Submission ID	Name	I / We	Name of organisation (if applicable)	Comments	Project team response
11008	Nigel Weston	have some concerns		<p>Regulatory speed limit changes are usually done in 20 km/hr increments. The change from 50 to 40 is negligible and will not, in my opinion, change the average speed in these streets significantly.</p> <p>No reference has been made to the results from applying this speed limit in Charleston where 40 km/h has been in place for many years?</p> <p>I suggest the limit be 30 km/h as has been done in the CBD and is common in many European cities.</p> <p>A significant lowering of the risk to pedestrians of serious injury is gained by the lower speeds around 30km/h even from 40 km/h.</p>	<p>Thank you for your submission.</p> <p>The majority of the proposed area has recorded average speeds around or below 40km/h. Changing the posted speed limit from 50km/h to 40km/h is aligned with actual speeds and gives the proposed posted speed limit credibility in accordance with NZTA speed management guidelines and a recent revision to the Land Transport Road user Rule: Setting of Speed Limits 2017.</p> <p>Some streets within the proposed area have no traffic calming an

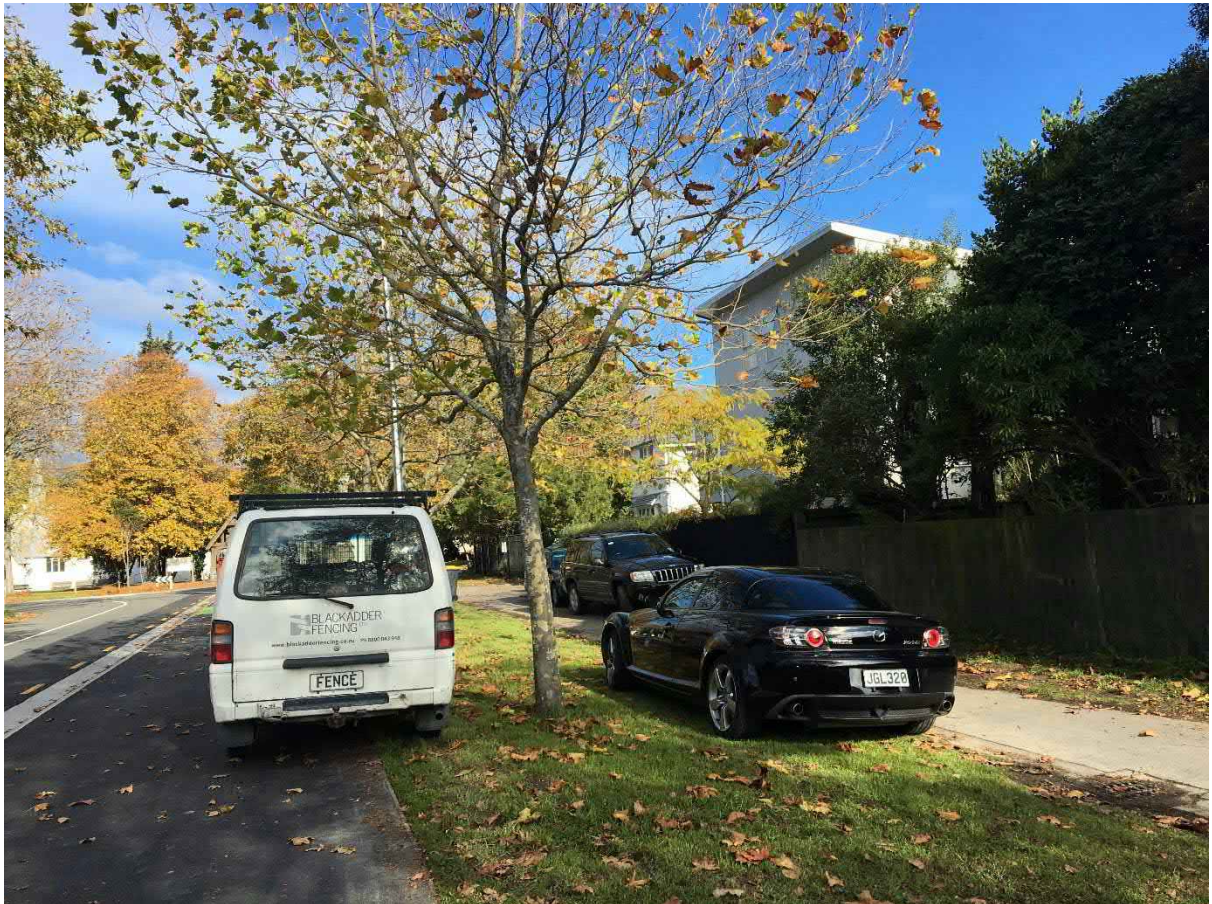
I am attaching a couple of photos to show the sort of things happening in Grove Road which could not be uploaded to the online survey send out recently.

I have more should they be necessary. The most important aspect of this whole issue is that 40 kp/h could be too fast. The street cannot cope with parking on the East Side of the street. People are stopping to let others through regularly and many have complained about the street since the recent changes have been made. It is decidedly dangerous, and if the parking was disallowed then it might work in a better way but still caution is necessary. At the end of the day 4-5 pm people are using Grove Road as a detour from Selwyn Street which does get very congested some days.

Submission ID	Name	I / We	Name of organisation (if applicable)	Comments	Project team response
10107	Helen Arnold			<p>I am attaching a couple of photos to show the sort of things happening in Grove Road which could not be uploaded to the online survey send out recently.</p> <p>I have more should they be necessary. The most important aspect of this whole issue is that 40 kp/h could be too fast. The street cannot cope with parking on the East Side of the street. People are stopping to let others through regularly and many have complained about the street since the recent changes have been made. It is decidedly dangerous, and if the parking was disallowed then it might work in a better way but still caution is necessary. At the end of the day 4-5 pm people are using Grove Road as a detour from Selwyn Street which does get very congested some days.</p> <p>Also it is now necessary to check for bikes both ways and traffic both ways. Some bikes do not even use the bike lane.</p> <p>I am sending in the other form as well but I cannot upload the photos. I have more.</p> <p>Many thanks Helen</p>	<p>Thank you for your submission.</p> <p>30km/h is more suited for roads with high volumes of pedestrians and cyclists such as town and city centres.</p> <p>The proposal is in a residential area with relatively high pedestrian and cycle numbers, but not high enough to justify a 30km/h posted speed limit.</p> <p>The parking issue on Grove Road has been raised as a customer service request CSR92364049 for the area traffic engineer to investigate.</p>

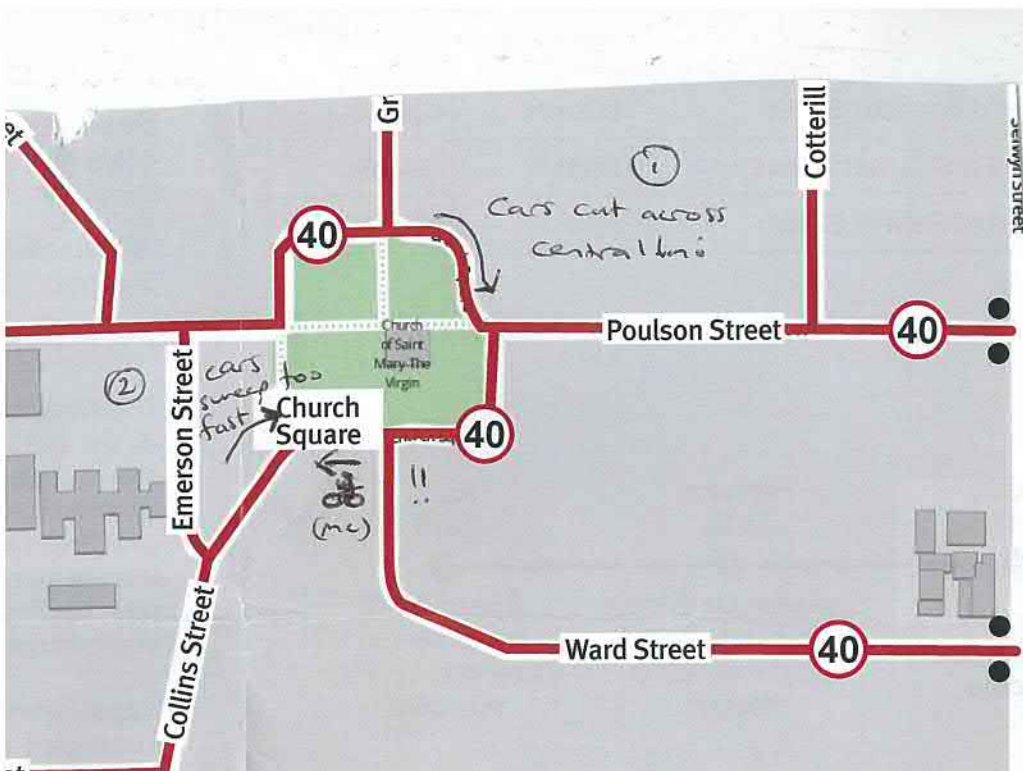
As a cyclist I support any measure  
 that assists motorists' awareness of  
 keeping speeds down around blind corners  
 and church square  
 For me there are the concerning sections  
 (see enclosed document)  
 Thank you  
 Honora Fenwick

cars sweep too fast

Cars cut across central bus

Submission ID	Name	I / We	Name of organisation (if applicable)	Comments	Project team response
10702	Bernard Lock	support the plan			Thank you for your submission.
10701	Julie Davison	support the plan			Thank you for your submission.
10700	Honora Renwick	support the plan		<p>As a cyclist I support any measure that assists motorist's awareness of keeping speeds down around blind corners and Church Square. For me there are the concerning sections (see enclosed document)</p> <p>Thank you Honora Renwick</p>	<p>Thank you for your submission.</p> <p>A customer service request CSR92364694 has been raised for the area traffic engineer to investigate.</p>
10690	Nicola Hart	support the plan		<p>My husband and I have two young kids, and we live on Poulson St between Church Square and Selwyn Street. We are very involved in our neighbourhood, we know a lot of people in the area, and my husband works in the area too. As a mum of young kids, we spend a lot of time walking the streets of this neighbourhood, and my husband and I also bike, skate and drive these streets. I have also lived on Cotterill Street, Harman Street, and Walsall and Kenilworth streets which are on the other side of Lincoln Road. Since being on Poulson Street with my kids, I have definitely noticed how much traffic there is and how fast people drive around our streets - particularly on our part of Poulson Street. I would say that people easily drive 60km/hour down our street. I would love to see the official speed limit be dropped in our neighbourhood, to make it safer, and more walking- and biking-friendly. Thanks!</p>	Thank you for your submission.
